**Re: Sunoco Pipeline LP – Pennsylvania Pipeline Project (Mariner East II)  
Chapter 102 Permit No. ESG0100015001– Major Amendment  
HDD S3-0290 Installation Method Change and Additional Temporary Workspace  
Upper Uwchlan Township, Chester County, PA  
Response to Technical Deficiency Letter**

**Comments and Responses to May 25, 2021 Technical Deficiencies:**

DATE:	2/6/17
PROJECT NO.:	112C05958
DESIGNED BY:	JB
DRAWN BY:	BH
CHECKED BY:	RS
COPYRIGHT TETRA TECH INC.	
<b>ES-6.28</b>	
SHEET 6.28 OF 99

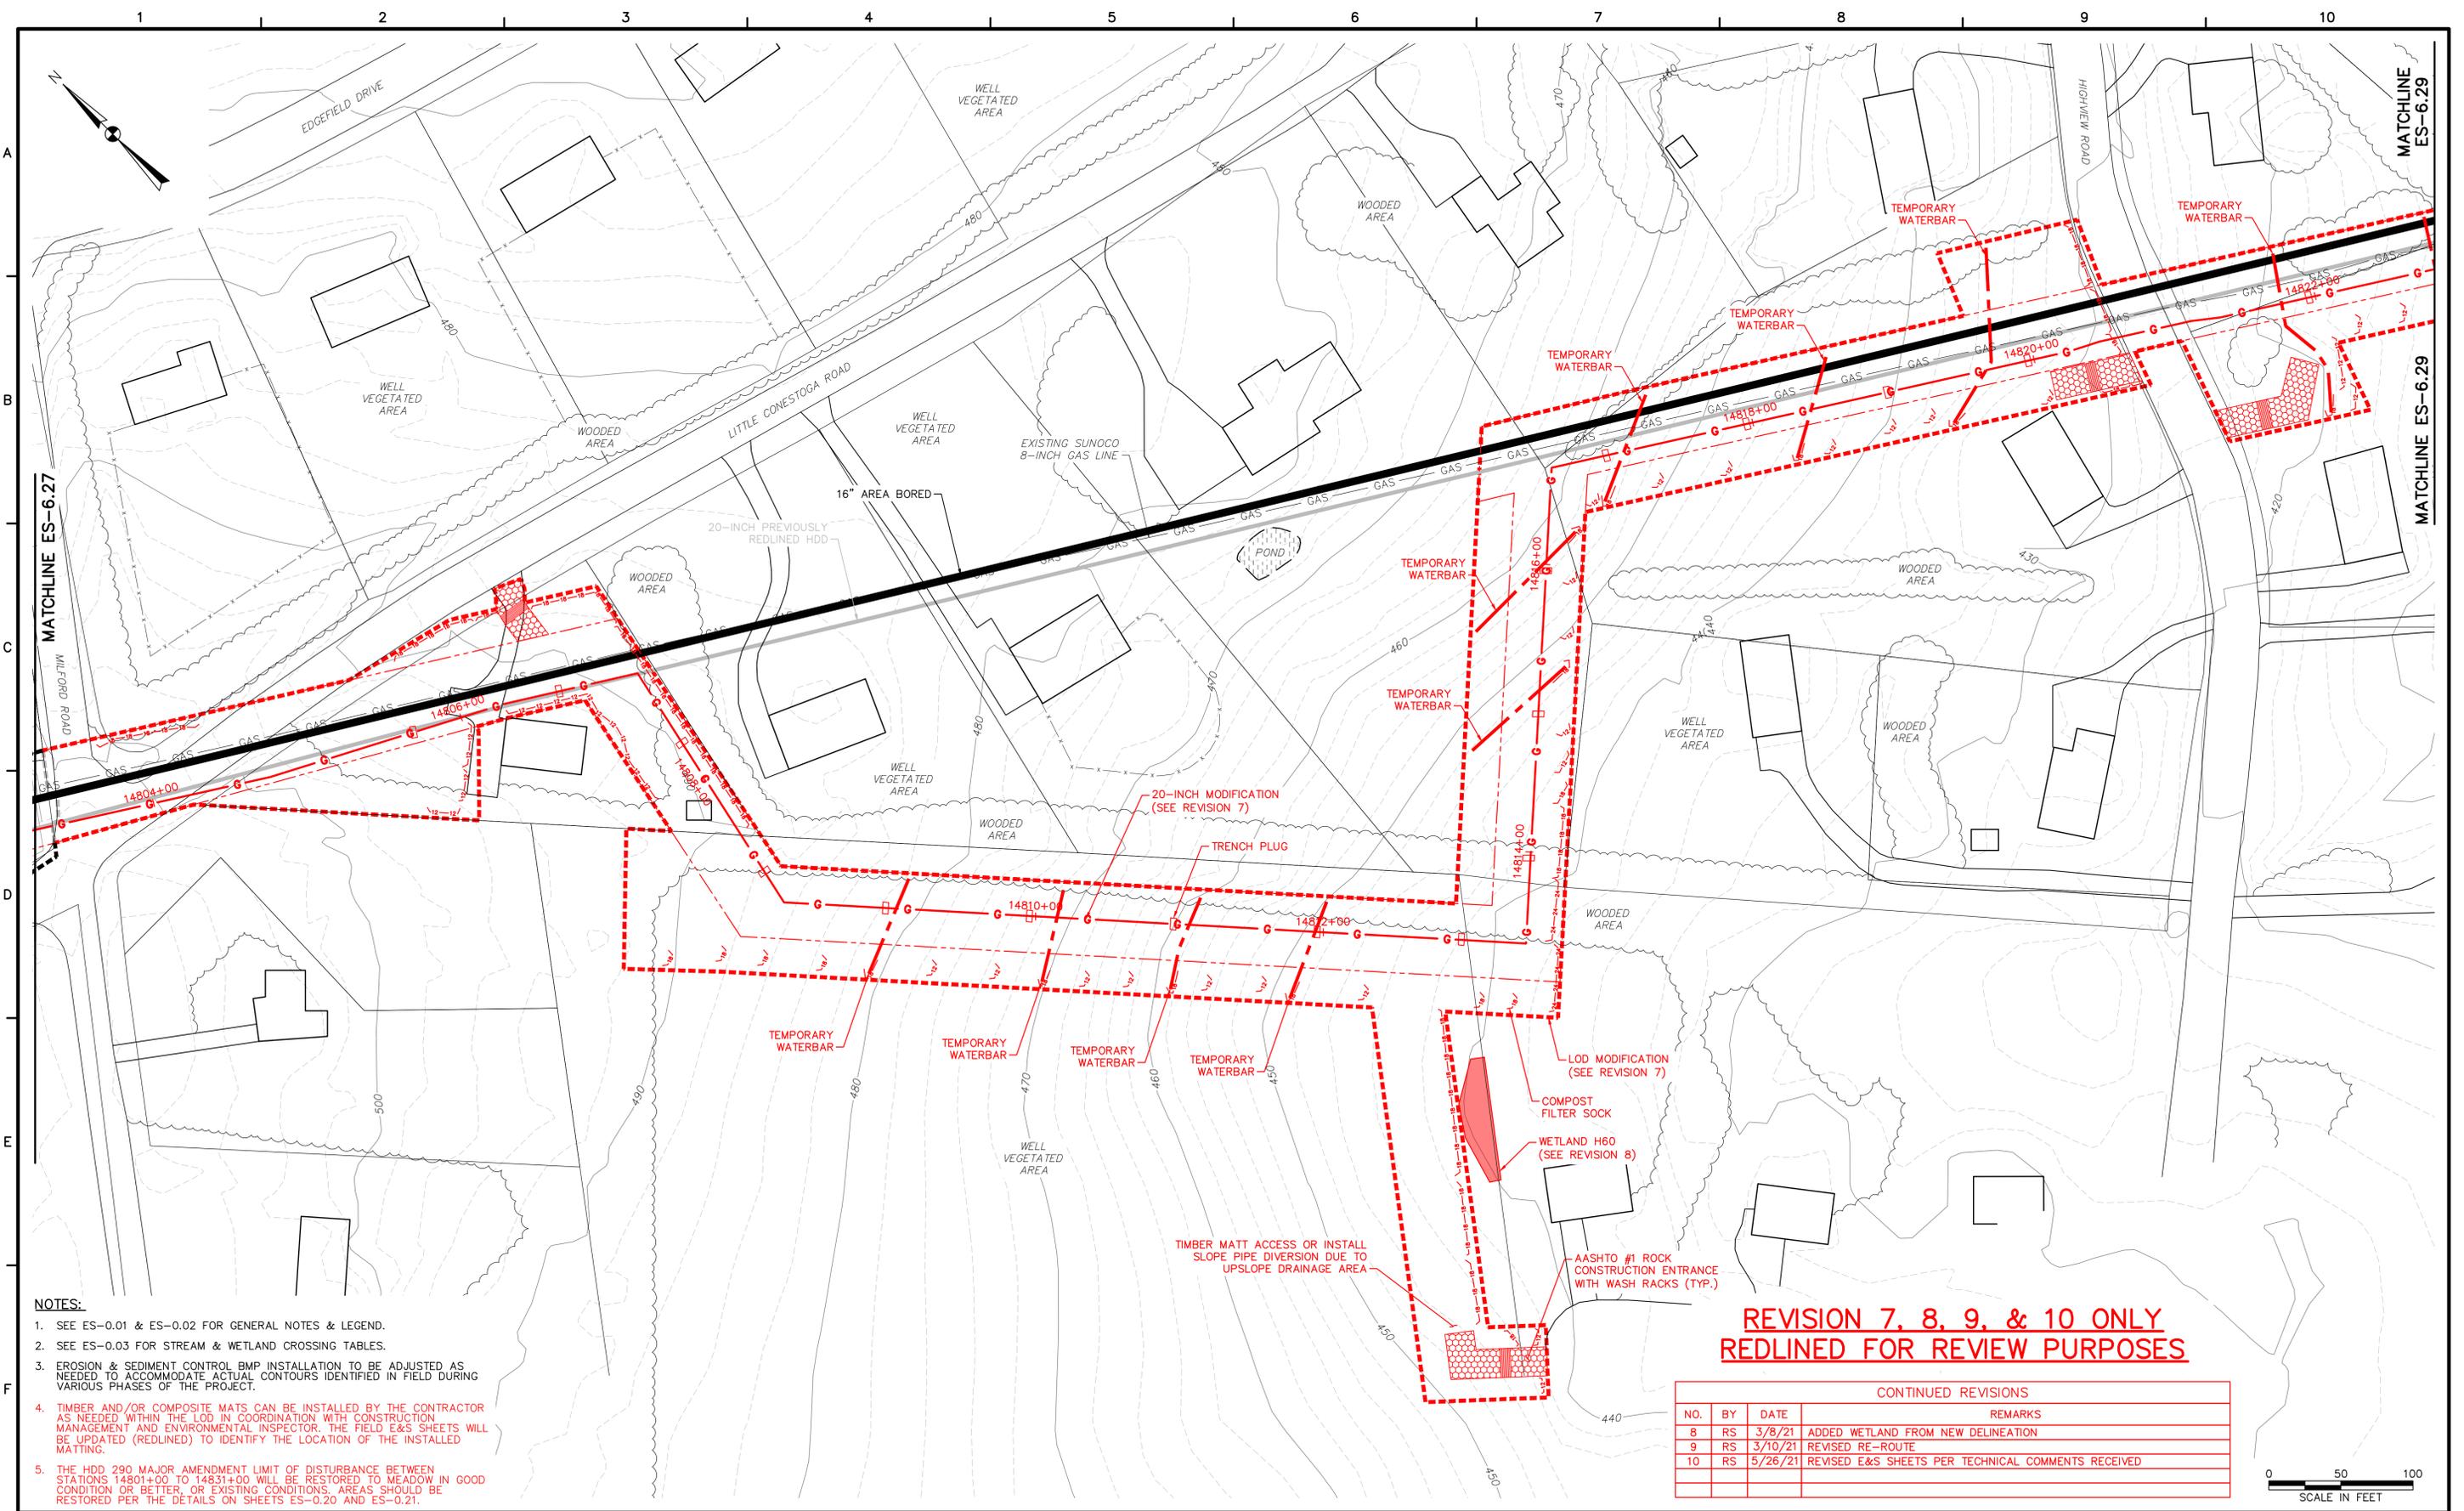
4. **Comment:** Please provide E&S Controls along the LOD adjacent to the existing house and driveway at station 14806+00. 102.11(a)(1)

5. **Comment:** There is off road LOD shown on the North East corner of the intersection of Milford and Little Conestoga Road, please provide E&S controls at this location. 102.11(a)(1)

*Response: Drawing ES-6.28 has been updated to provide 12-inch compost filter sock (CFS) along driveway and along LOD near the house. Updated E&S Drawings are provided as Attachment A.*

*Response: Drawing ES-6.28 has been updated to show CFS in this area. Updated E&S Drawings are provided as Attachment A.*

DATE:	2/6/17
PROJECT NO.:	112C05958
DESIGNED BY:	JB
DRAWN BY:	BH
CHECKED BY:	RS
COPYRIGHT TETRA TECH INC.	
<b>ES-6.29</b>	
SHEET 6.29 OF 99

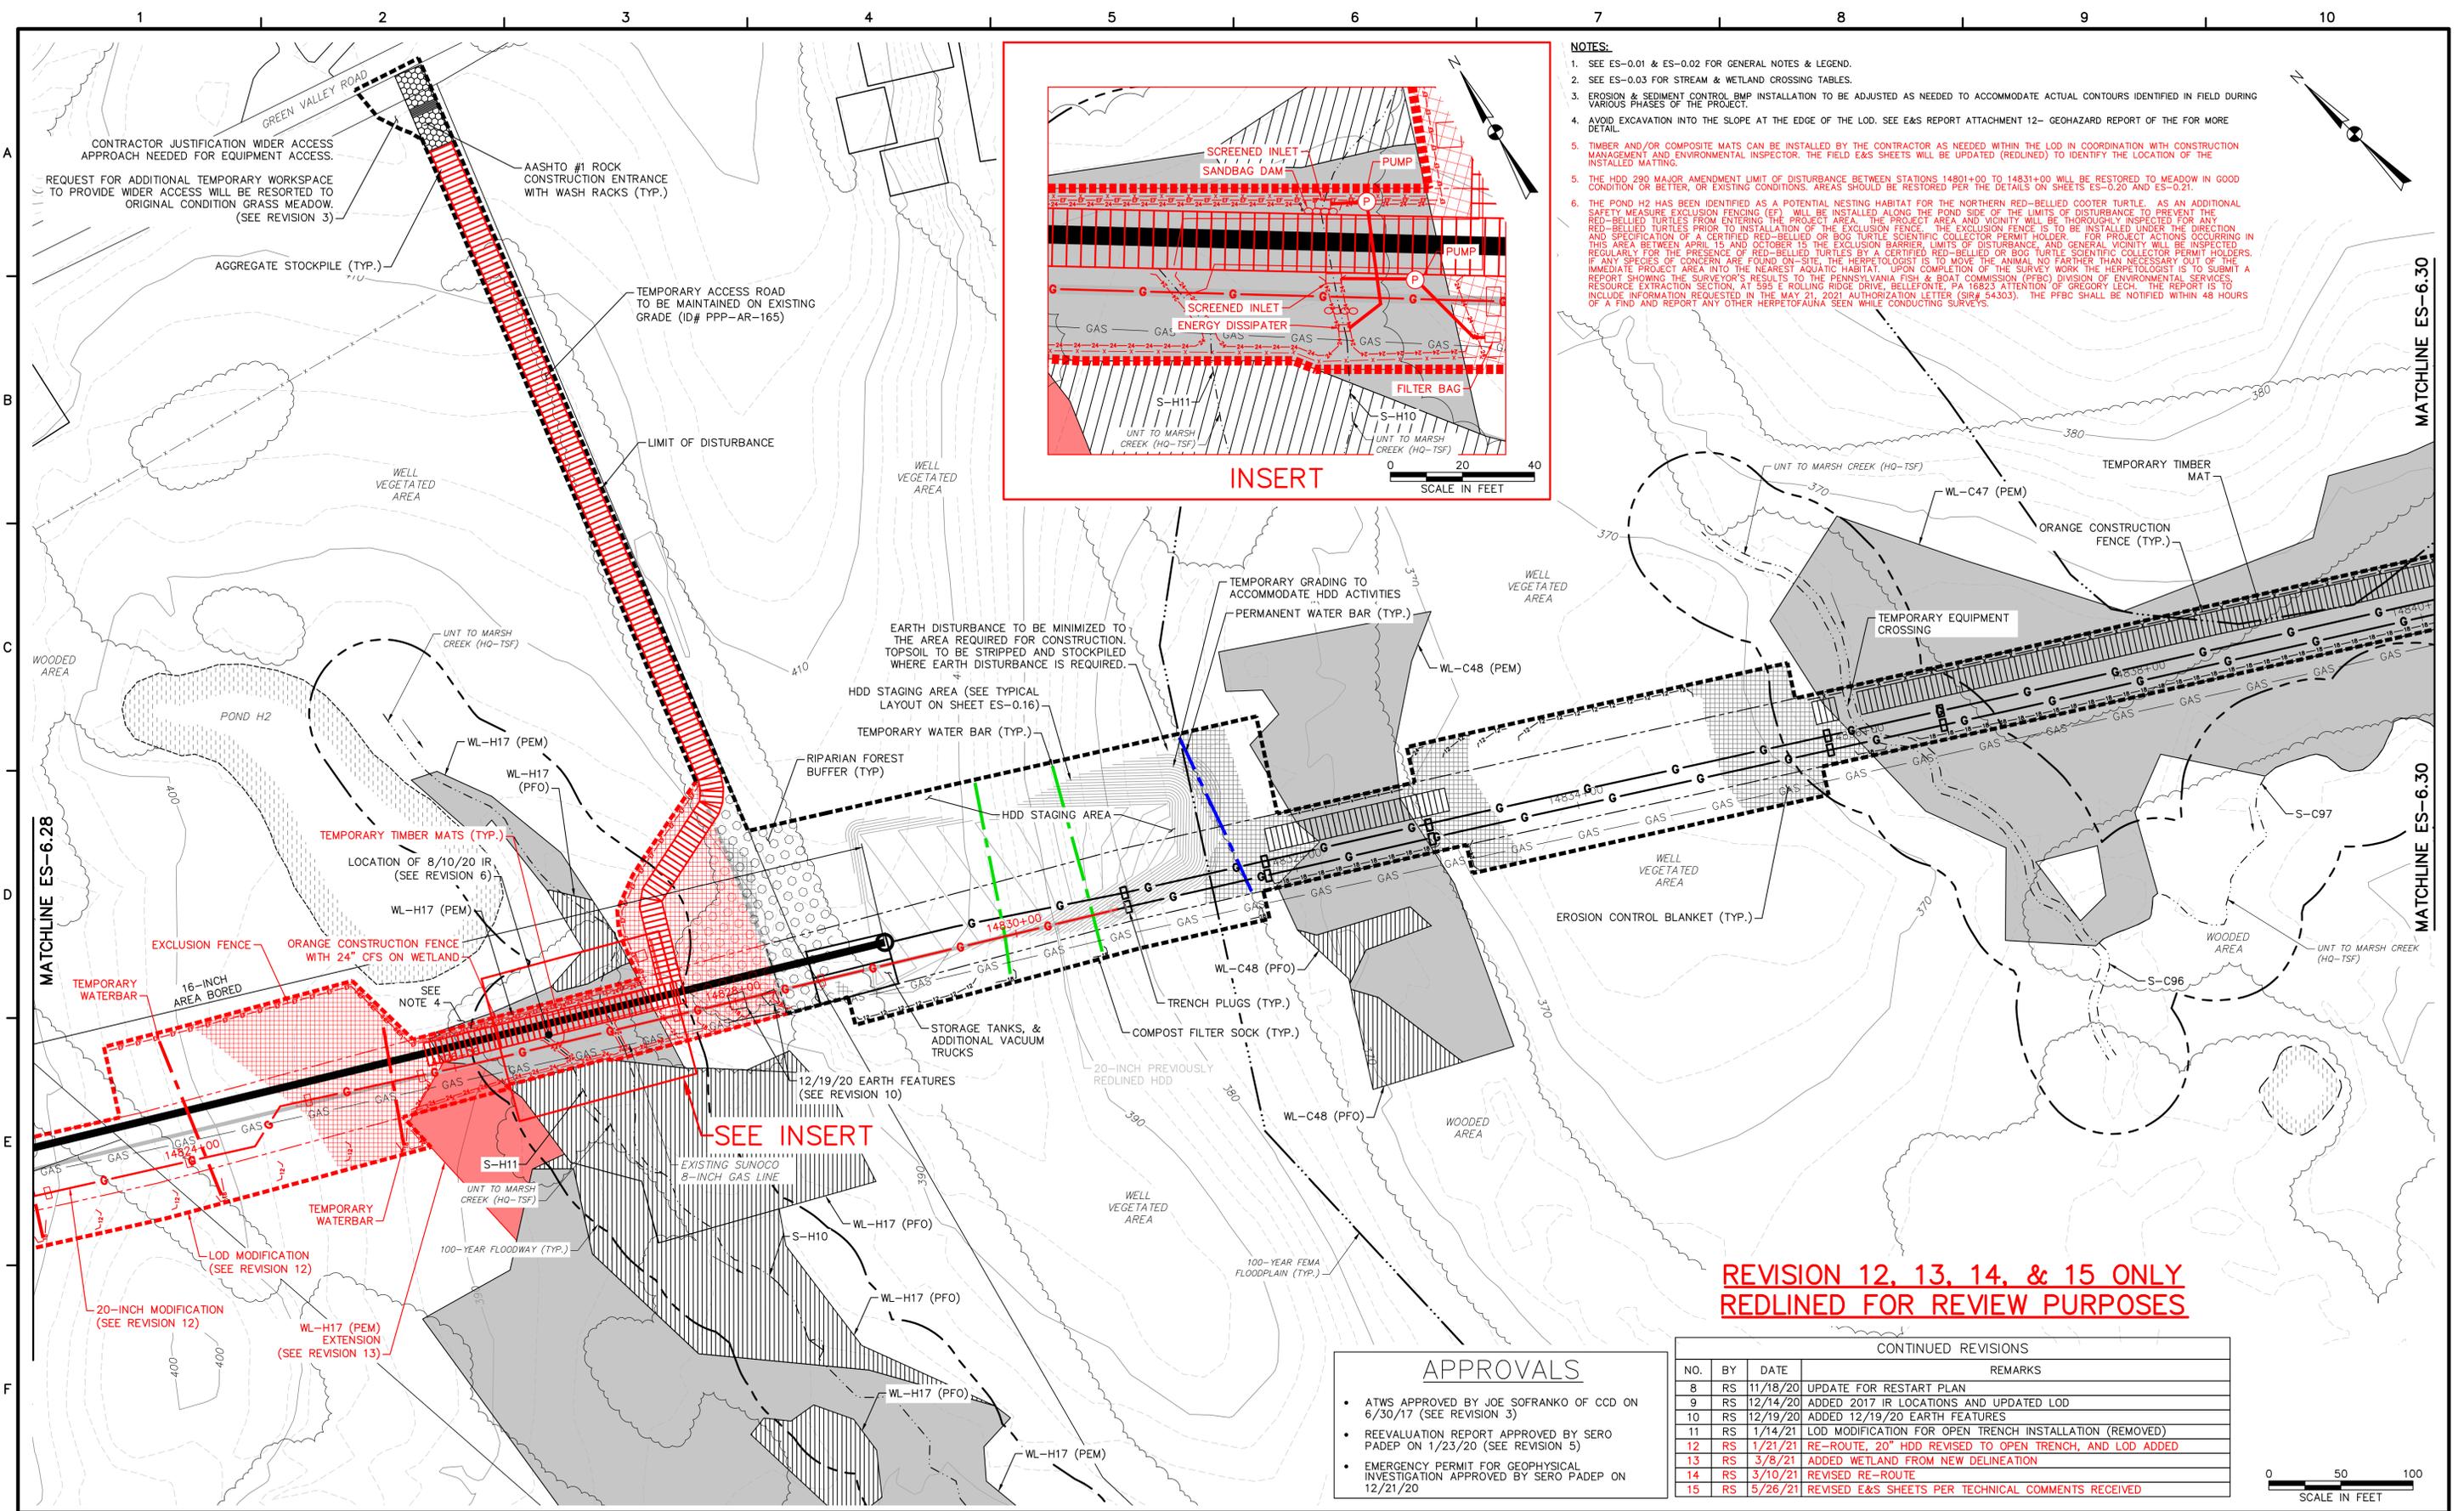
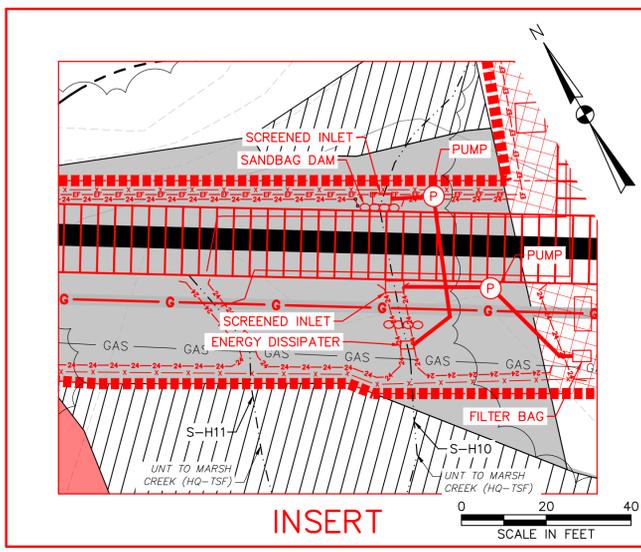
1. **Comment:** Please utilize a minimum of 24" Filter Sock adjacent to streams and wetlands. See adjacent to wetland H60, WL H17, etc. Check entire Major Mod plan and revise as needed. 102.4(C)

3. **Comment:** Please clearly illustrate the stream crossing including the method of stream diversion on the plan mapping and provide a blow up of the stream crossing bypass system. 102.11(a)(1)

*Response: Drawing ES-6.29 has been update accordingly. ES-6.29 is the only sheet in the amendment area containing resources. Updated E&S Drawings are provided as Attachment A.*

*Response: Drawing ES-6.29 has been updated to include a blow up insert of the proposed dam and pump bypass to be implemented for the open trench installation across stream S-H10. Updated E&S Drawings are provided as Attachment A.*
